SAN FRANCISCO PLANNING DEPARTMENT

Discretionary Review Abbreviated Analysis HEARING DATE: AUGUST 12, 2010

Date: August 5, 2010
Case No.: **2009.0640D**
Project Address: **380 – 382 19th Avenue**
Zoning: RM-1 (Mixed, Low-Density)
40-X Height and Bulk District
Block/Lot: 1450/019C
Project Sponsor: Hawk Lee
1609 Noriega Street
San Francisco, CA 94122
Staff Contact: Sara Vellve – (415) 588-6263
Sara.Vellve@sfgov.org
Recommendation: **Do not take DR and approve as proposed**

NORTH ELEVATION
(3/16" = 1'-0")

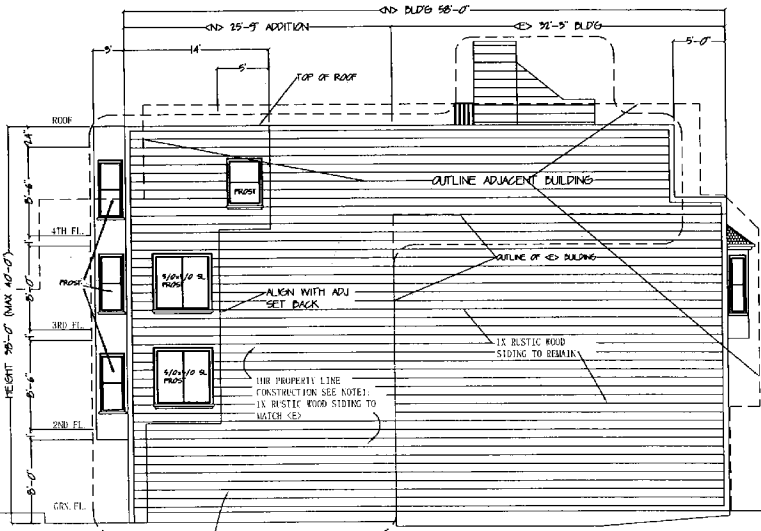
THERE WILL BE AN EXTRAORDINARY INVASION OF PRIVACY AND EXCEPTIONAL LOSS OF SUNLIGHT WITH THE CURRENT PLANS, WHICH HAS THEIR PROPOSED NORTH-FACING DOORS, DECKS, AND WINDOWS DIRECTLY OPPOSITE SIX OF OUR BUILDING'S WINDOWS. THE HEIGHT OF THEIR BUILDING AND PENTHOUSE WILL ALSO BLOCK SEVERAL HOURS OF SUNLIGHT TO OUR WINDOWS AND THIRD FLOOR SKYLIGHT.

- 1) INCREASE SETBACK FROM 3 FEET TO 5 FEET (JUST LIKE OUR BUILDING), WHICH WILL HELP IN NOT BLOCKING OUR SUNLIGHT.
- 2) ELIMINATE PENTHOUSE SO THAT IT DOES NOT FURTHER BLOCK OUR SUNLIGHT AND VIEWS. IF BUILT, IT WILL BE HIGHER THAN OUR BUILDING.
- 3) MOVE FOURTH FLOOR DOOR SO THAT IT DOES NOT OPEN DIRECTLY OPPOSITE OUR WINDOW. IF NOT POSSIBLE, PLEASE ELIMINATE THE DOOR.
- 4) MOVE SMALL DECK (3' X 3') ON FOURTH FLOOR SO THAT ITS ~~DOOR~~ NOT DIRECTLY OPPOSITE OUR 2 WINDOW. IF NOT POSSIBLE, PLEASE ELIMINATE DECK.
- 5) MOVE SECOND FLOOR SLIDING GLASS DOOR SO THAT IT IS NOT DIRECTLY OPPOSITE OUR SECOND FLOOR WINDOWS. IF NOT POSSIBLE, PLEASE ELIMINATE SLIDING GLASS DOOR.

In response to the issues raised by the DR Requestor, the Project Sponsor has increased the width of a side setback adjacent to the DR requestor from three to five feet, eliminated decks within the side setback and replaced doors with windows, proposed frosted glass on all windows facing the DR requestor and eliminated a door in the developed area of the ground floor.

The request for Discretionary Review was reviewed by the Department's Residential Design Team (RDT) on September 3, 2009. The RDT found that a five foot setback along the north side property line should be provided. The proposal has been revised to provide this setback; therefore, there are no exceptional or extraordinary circumstances associated with the property or the project. Based on the following findings, the RDT determined that this Project should be approved as proposed, and categorized as an Abbreviated Discretionary Review:
